WASTE MANAGEMENT FACILITY AT DDE ATTARD LTD, LUQA

VOLUME 3: RESPONSE TO FEEDBACK ON IPPC APPLICATION

Version 3: April 2019

End-of-life vehicles (Option 1 – as described in Volume 2):

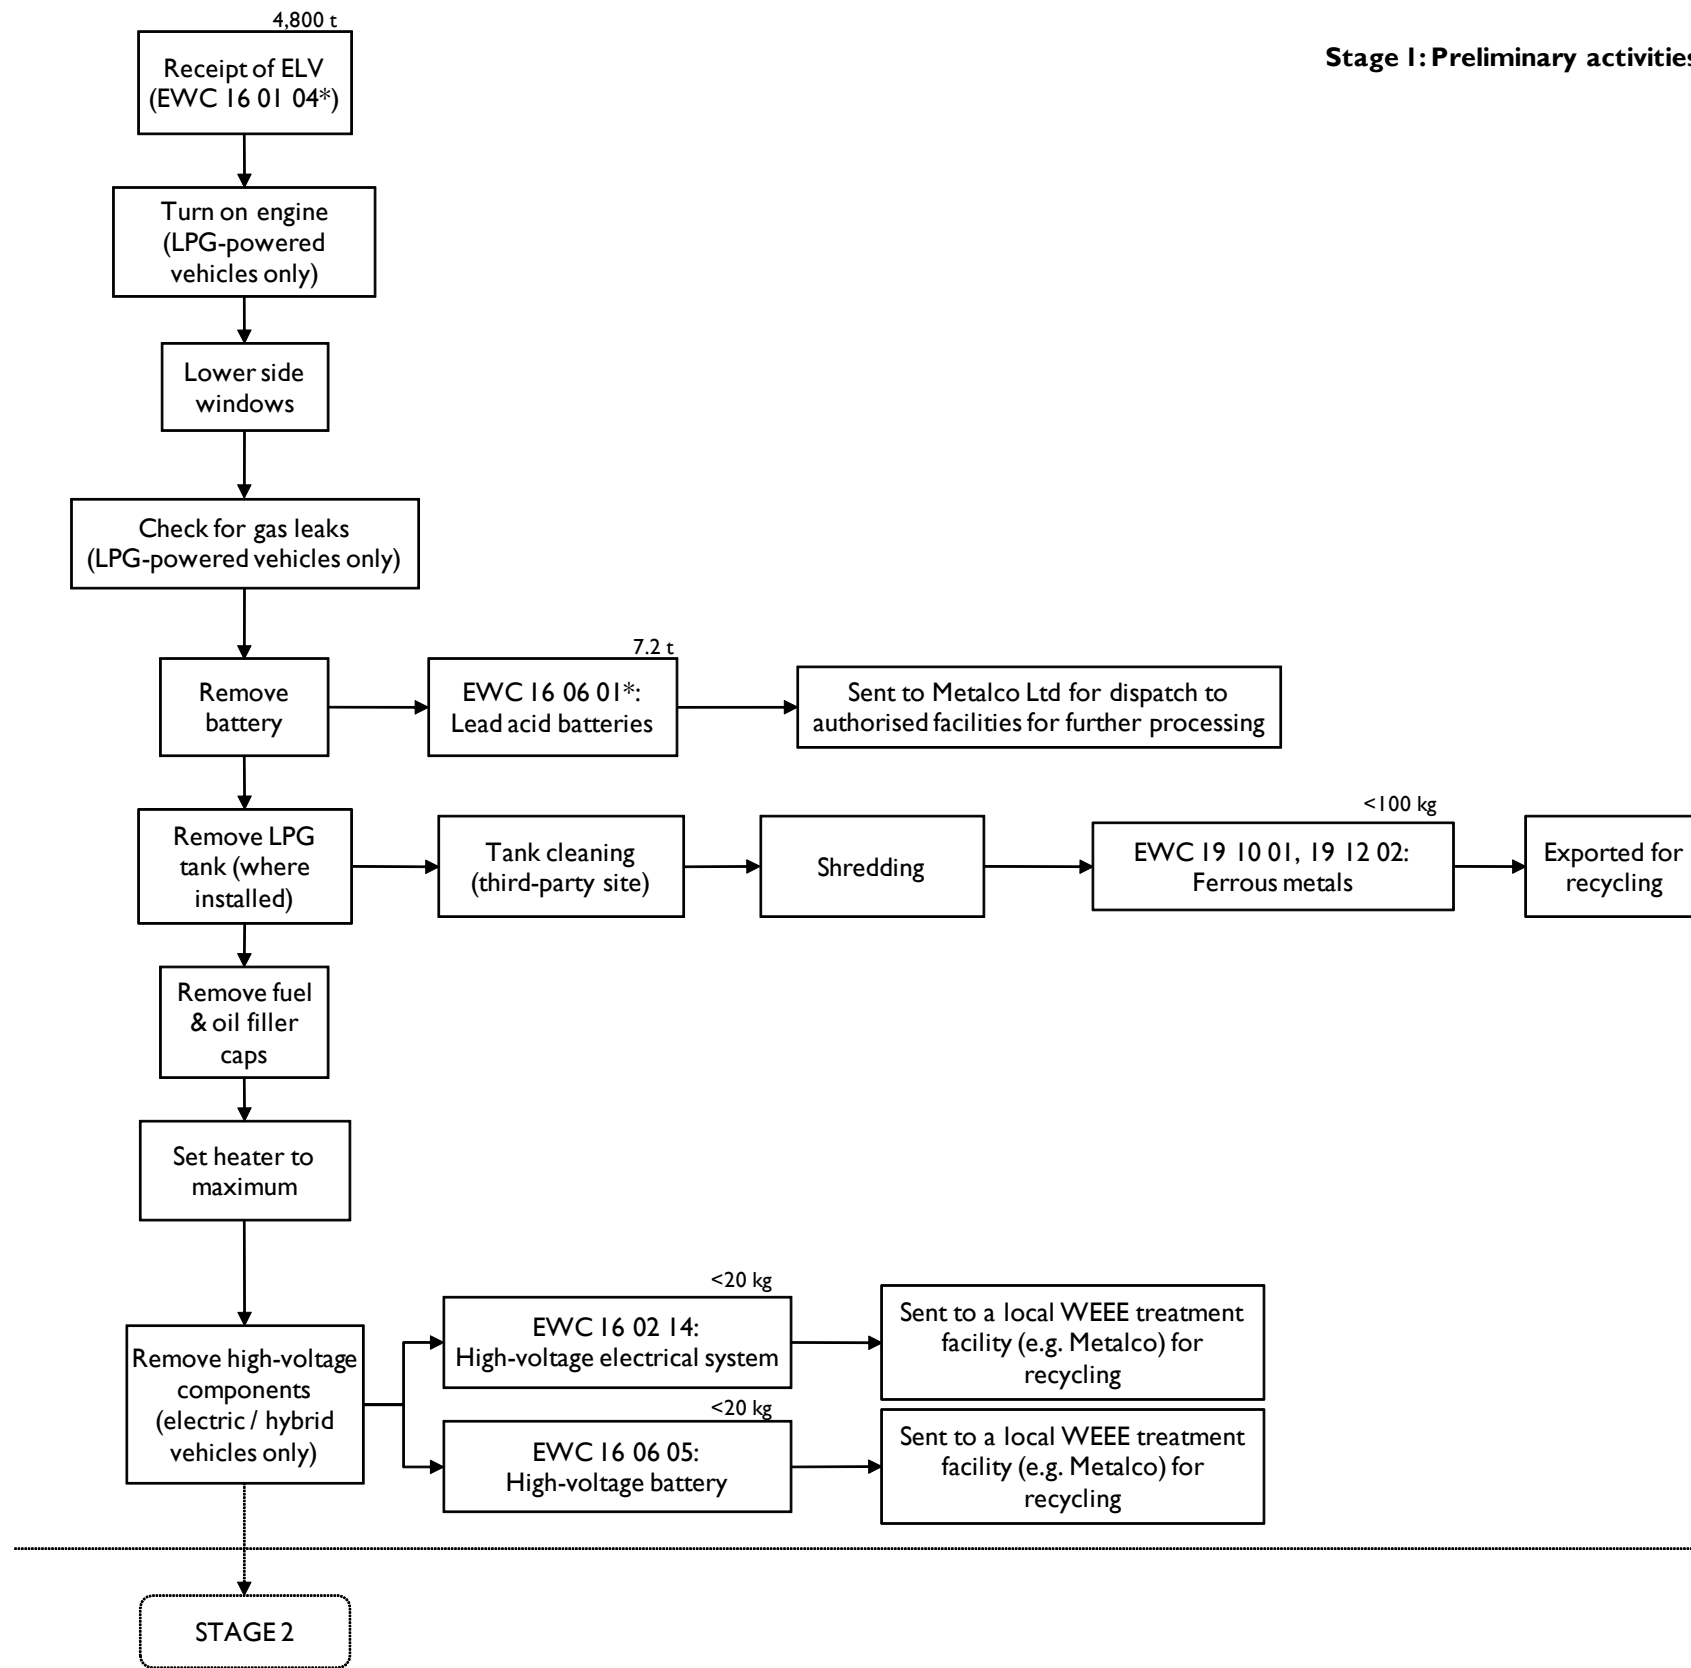
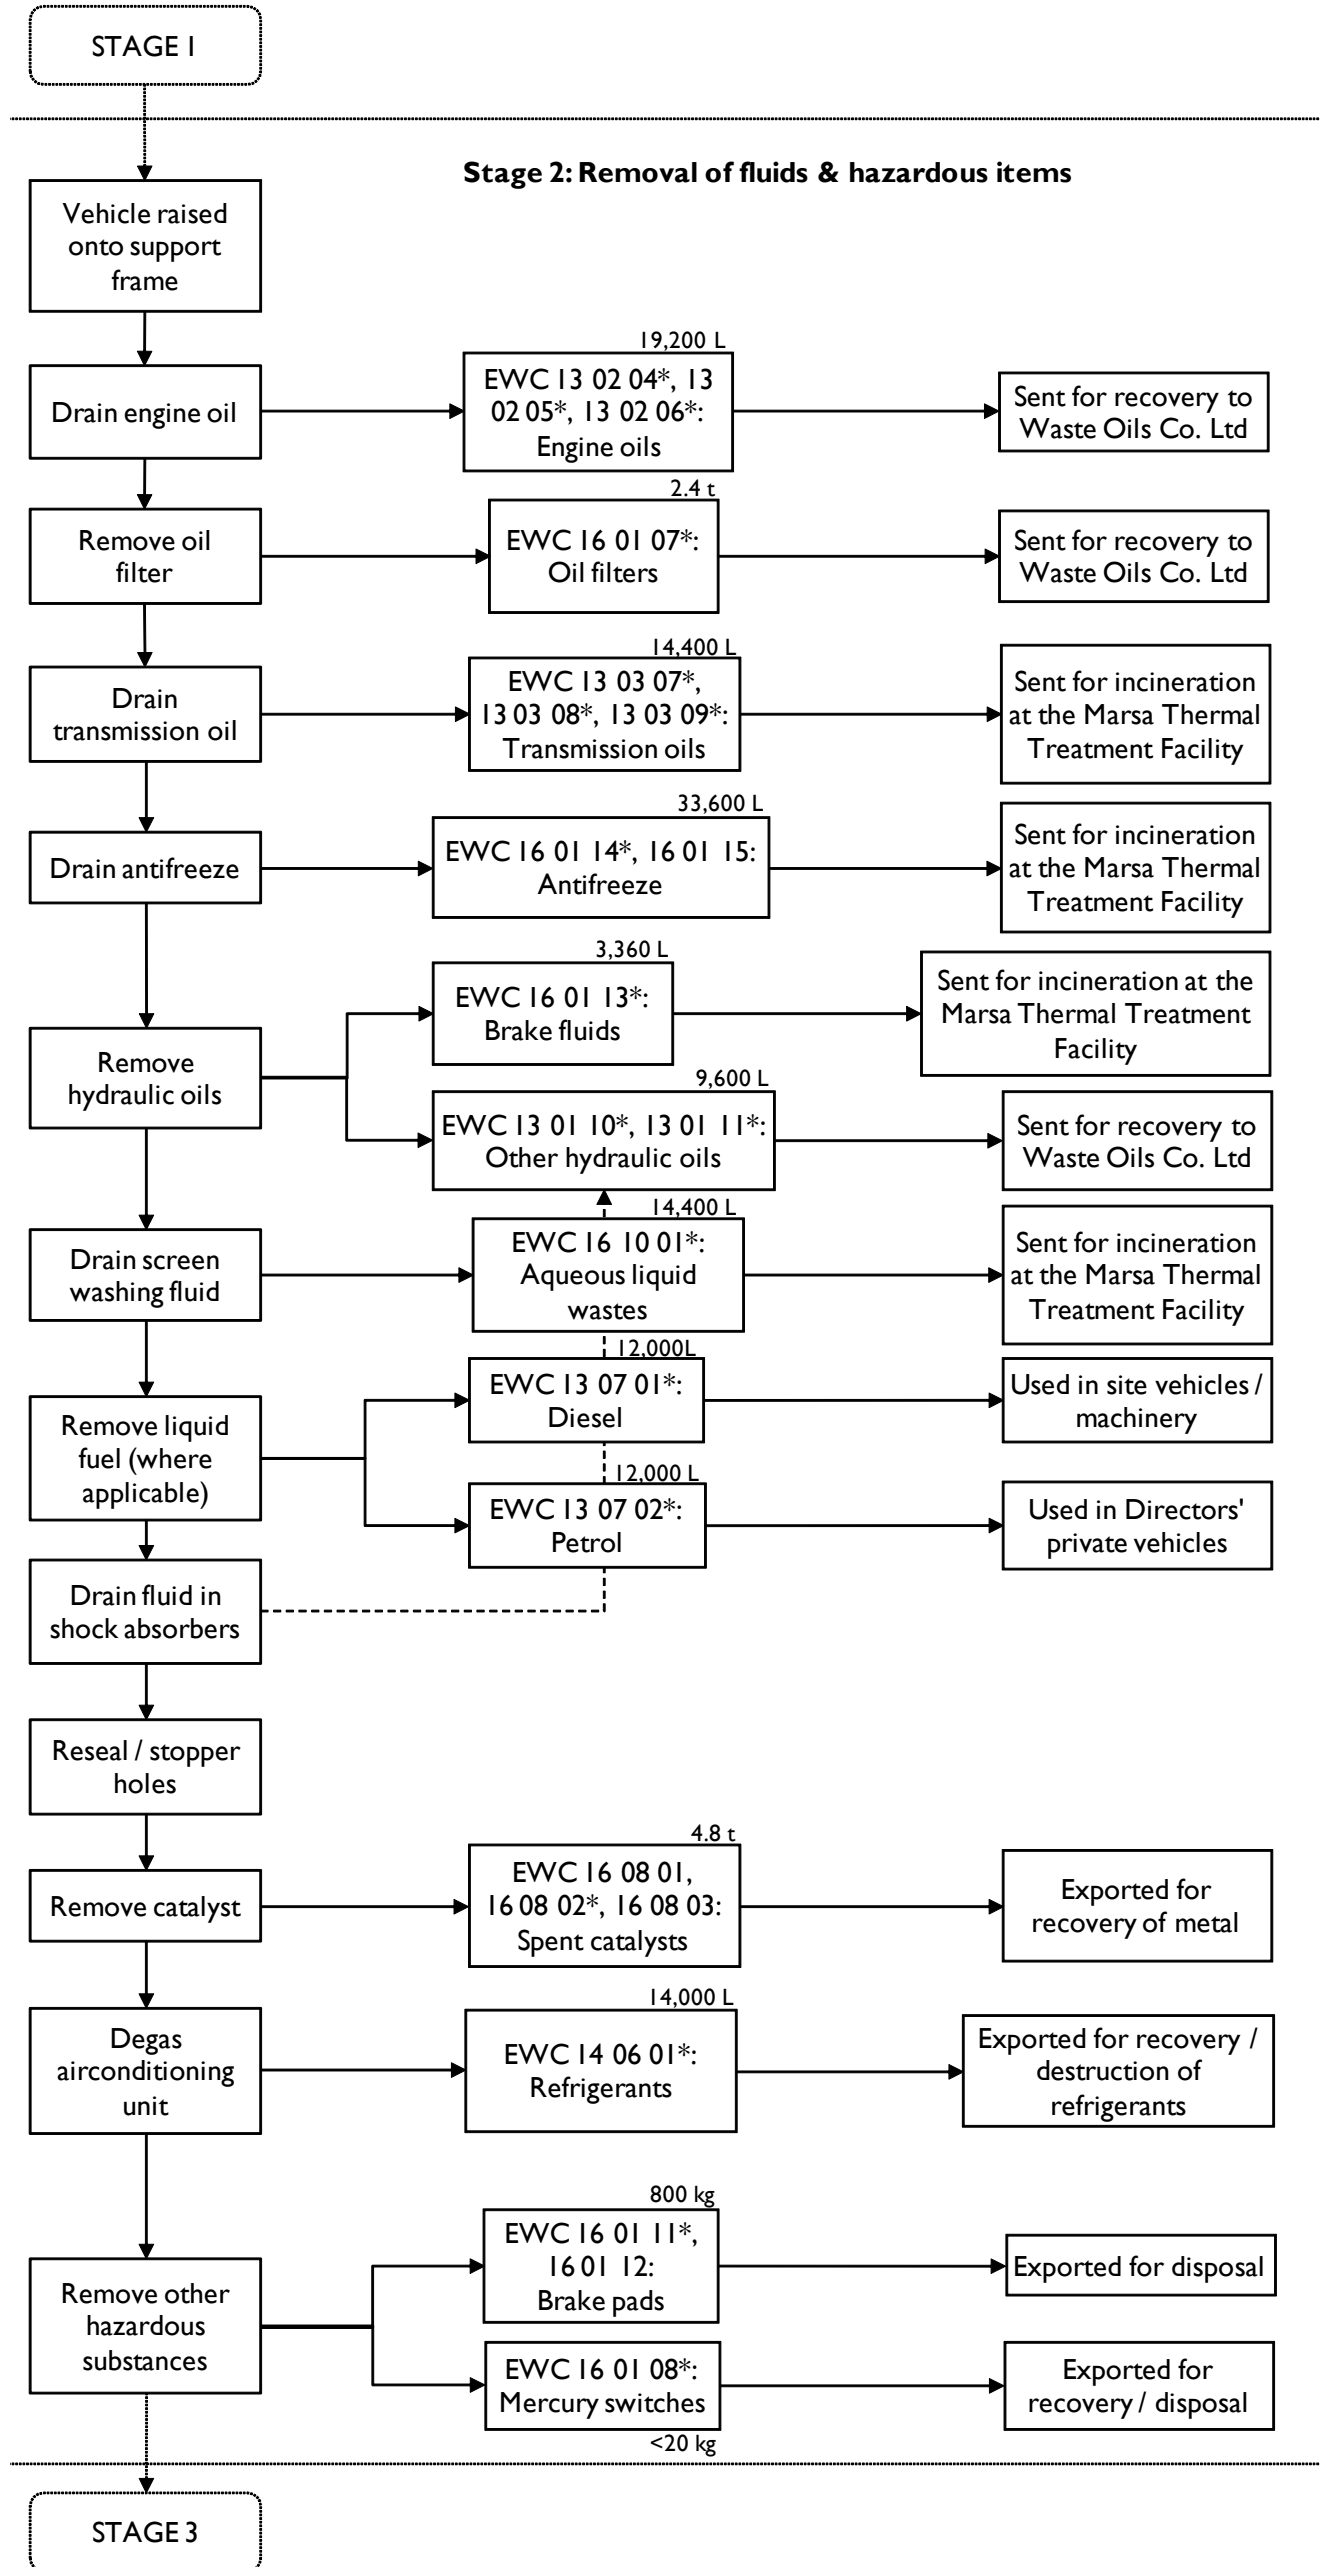
6. Kindly note that Sant'Antnin Waste Treatment Plant is not authorised to accept EWC codes 19 12 04 and 19 12 05 which are indicated to originate from the processing of washing machines, cookers, wood and wire stripping. With regards to wood processing, applicant is to distinguish between wood treated with hazardous substances and that which is not. Any processed waste which shall be sold as a product (e.g. wood for use in fireplaces, compost) is to be covered by an End-of-Waste Certificate. Kindly find attached End-of-Waste application form and contact the Waste Team at ERA on georgesam.mizzi@era.org.mt for further assistance	Noted. The receiving waste management facility permits will be checked before transfers of waste, and when required alternative authorised waste management facilities will be used. Noted.	Alternative permitted facilities or waste broker permits are to be immediately suggested to dispose of such wastes. Flow diagrams are to be updated accordingly. End-of-Waste applications are to be submitted immediately to the Environmental Permitting Unit as part of the IPPC application.	Green Skip Services Ltd will be used; this is permitted by IP 0001/12/A for this EWC code ² . However, as mentioned, alternative licensed facilities will be used during operation of the Scheme as the need arises. The applicant has decided not to pursue the sale of shredded wood. This will instead be sent to the Ta' Żwejra or Ghallis non-hazardous engineered waste facilities (permitted by IP 0001/05/B and IP 0001/06/B respectively). Updated flow diagrams for these processes are included in Attachment 4 .
